GENESIS ENGINEERING & REDEVELOPMENT

Subject: Work Plan Addendum
Best-DDK Cleaners
38-68 13th Street, Long Island City, New York
Site Number 241126

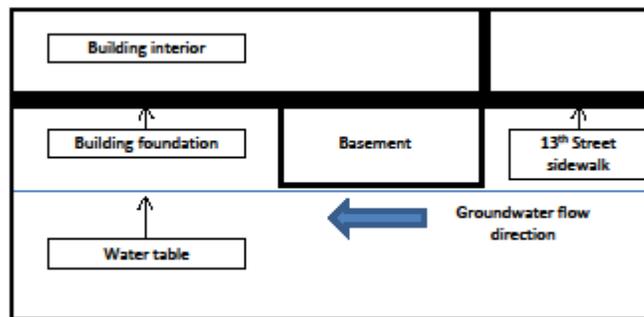
3. NYSDOH Comment 3 suggests that the groundwater contamination in the wells upgradient of the Site building is the result of a sub-slab source “spreading” to impact the groundwater. As noted in the Report, there is a partial basement located in the northeastern portion of the Site building (reference is made to Figures 3 through 6 of the Report) and groundwater was encountered within approximately

eight inches below the bottom of the basement floor slab (the following sketch shows this layout). Since the basement wall would act as a barrier to migration of contamination from beneath the slab, it is highly unlikely that any contaminants from a sub-slab source would be migrating in an upgradient direction through spreading. Further evidence of this is that the least-impacted soil vapor sample (GER-SV5) was collected below the basement floor slab in the front of the Site building and the most highly impacted groundwater sample (GER-2) was collected in the sidewalk near the street in this area (see Report Figures 6 and 7 for these sample locations).
